**GLENORCHY PLANNING AUTHORITY MEETING  
AGENDA  
MONDAY, 17 FEBRUARY 2025**

**5. PROPOSED USE AND DEVELOPMENT - MULTIPLE DWELLINGS  
(ONE EXISTING, ONE PROPOSED) - 2 NARELLE PLACE  
CLAREMONT**

<b>Application No.:</b>	PLN-24-288
<b>Applicant:</b>	James Ho Architecture
<b>Owner:</b>	Q Nguyen
<b>Zone:</b>	General Residential
<b>Use Class</b>	Residential
<b>Application Status:</b>	Discretionary
<b>Discretions:</b>	8.4.3 Site coverage and private open space for all dwellings P2 8.4.6 Privacy for all dwellings P3 C2.5.1 Car parking numbers P1.2
	(The proposal meets all other applicable standards as demonstrated in the attached appendices)
<b>Level 2 Activity?</b>	No
<b>42 Days Expires:</b>	29 January 2025
<b>Existing Land Use:</b>	Single dwelling
<b>Representations:</b>	0
<b>Recommendation:</b>	Approval subject to conditions

Figure 1: Proposed site plan (source: Applicant) note the image on the right shows the full floor plan of the existing dwelling and the carparking area.

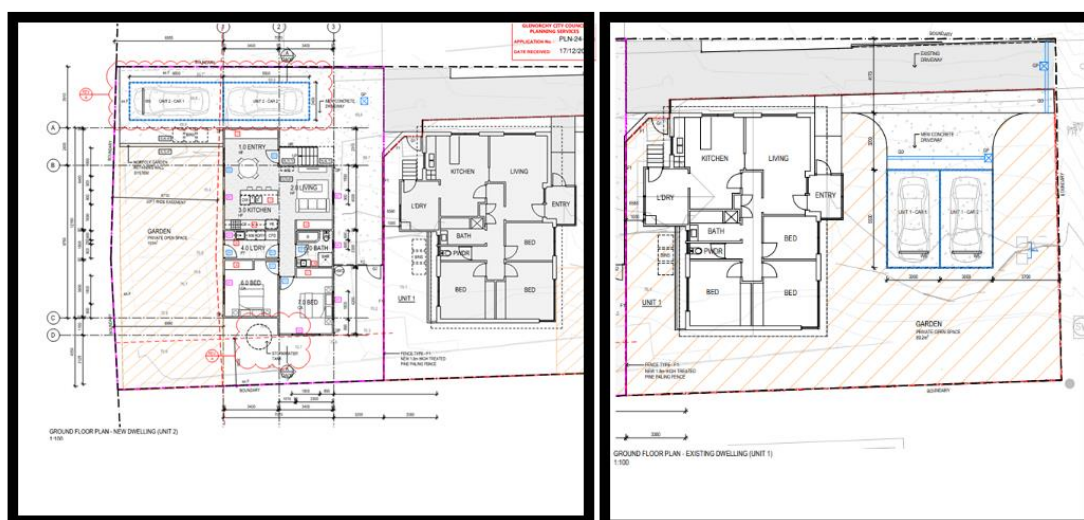
The open space for the existing dwelling is located in the front setback, and while it does have a northern aspect, the site frontage is orientated east/west.

The private open space area is within the front setback and so can be accessed from the entrance of the dwelling, noting the living room is adjacent the front entrance on the current floor plan. The 'convenience' of access to the living room therefore needs consideration. The site is relatively flat, and the open space is in close proximity to the entrance / living area, its proximity to the living area and relative ease of access could be considered as 'convenient'.

The private open space area of the front dwelling, noting that it is located to the south of the proposed car parking areas, has a northerly aspect, would receive adequate sunlight and is of a reasonable dimension to enable children's play and outdoor relaxation.

While the location of the open space area in relation to the dwelling is not ideal, it is of a significant size, can be considered convenient to access and has good solar access. It is considered that the proposal meets the performance criteria and can be considered to satisfy the standard.

The proposal includes a shared driveway and parking spaces that are less than 1m from habitable room windows of dwellings. It is unclear from the submitted plans if the window sill heights of these windows are not less than 1.7m above the shared driveway. Therefore, the proposal relies on the performance criteria as follows:

A condition will be required to ensure that it can be demonstrated that the sill heights of the northern kitchen and living room windows are a minimum of 1.7m above the shared driveway or adequate screening is provided.

- (a) The northern kitchen and living room windows of Unit 1 (existing dwelling) have a sill height of not less than 1.7m above the shared driveway, or have fixed obscure glazing extending to a height of not less than 1.7m above the floor level; or
- (b) A screen of not less than 1.7m in height above the shared driveway, is provided between the southern side of the shared driveway and the northern kitchen and living room windows of Unit 1 (existing dwelling).
